## FOR: Lenoir County Administration Building – Interior Renovation

## ADDENDUM NO. 4

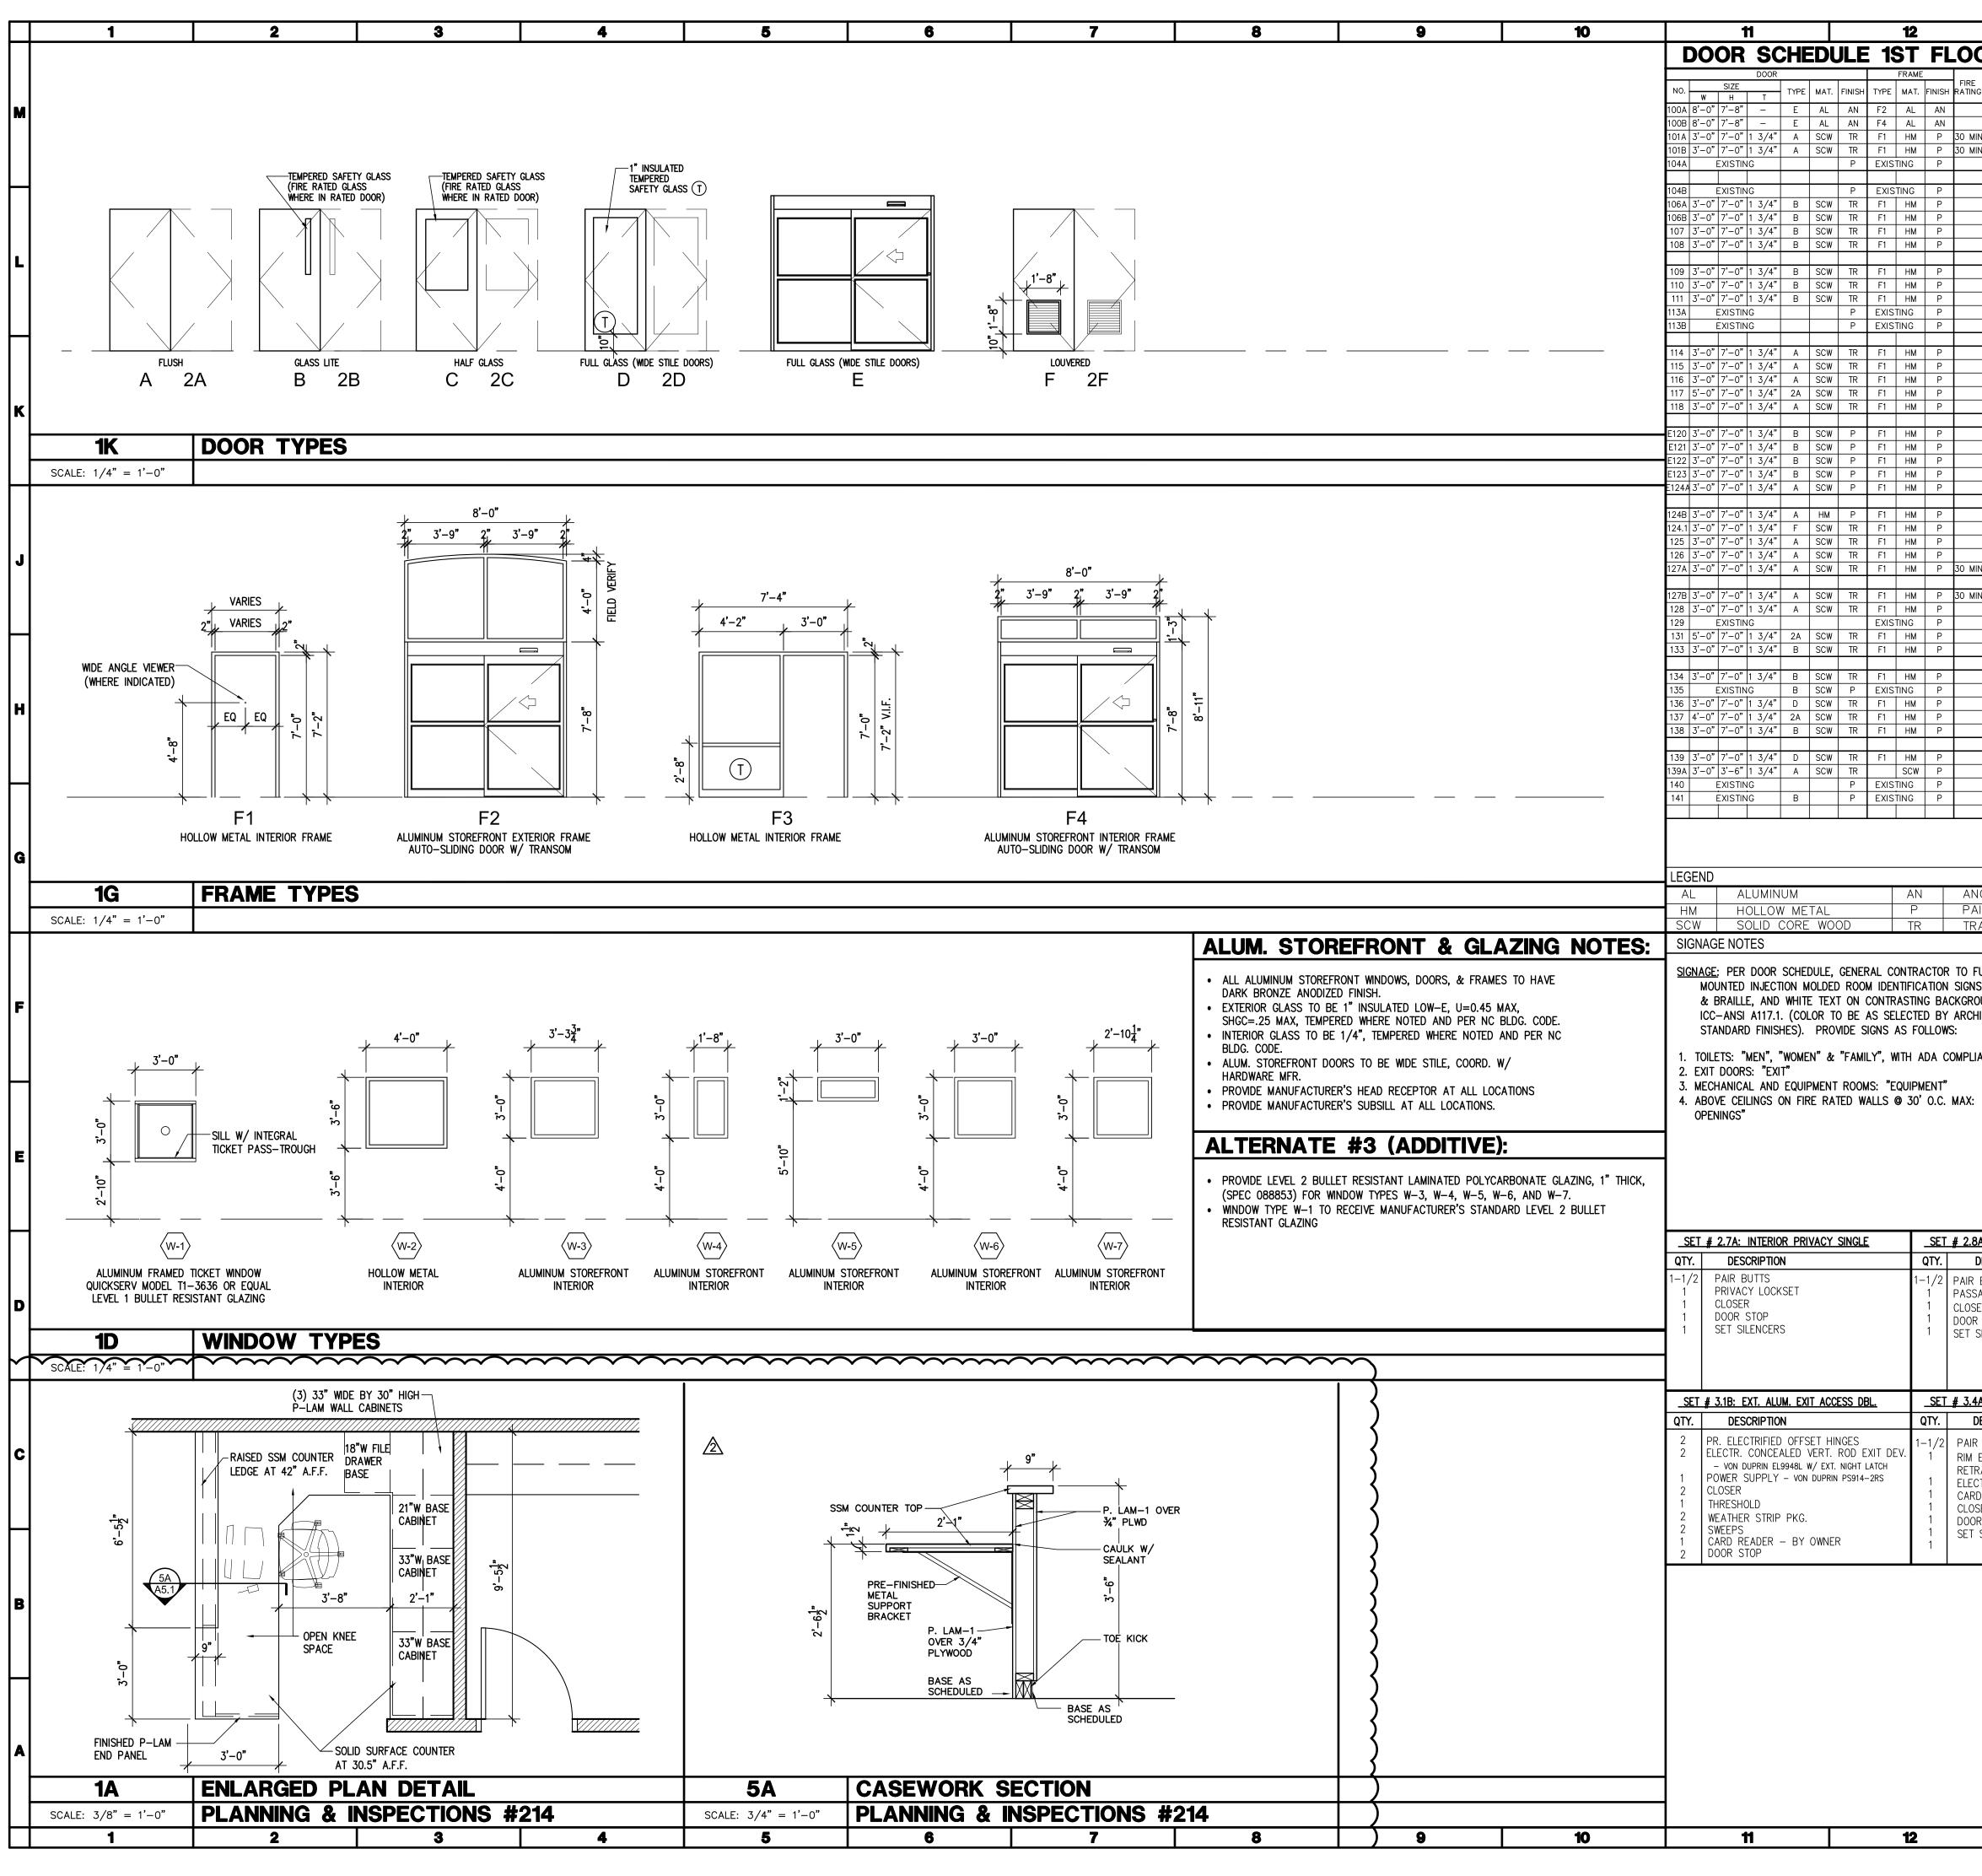
g. The plan view for Planning & Inspections shows a U-shaped assembly that contains a transaction area that does not appear to be elevated. Please provide additional details for this assembly if it is to be new casework.

**RESPONSE:** See details 1A and 5A on the attached revised sheet A5.1 to include details for the construction of this desk.
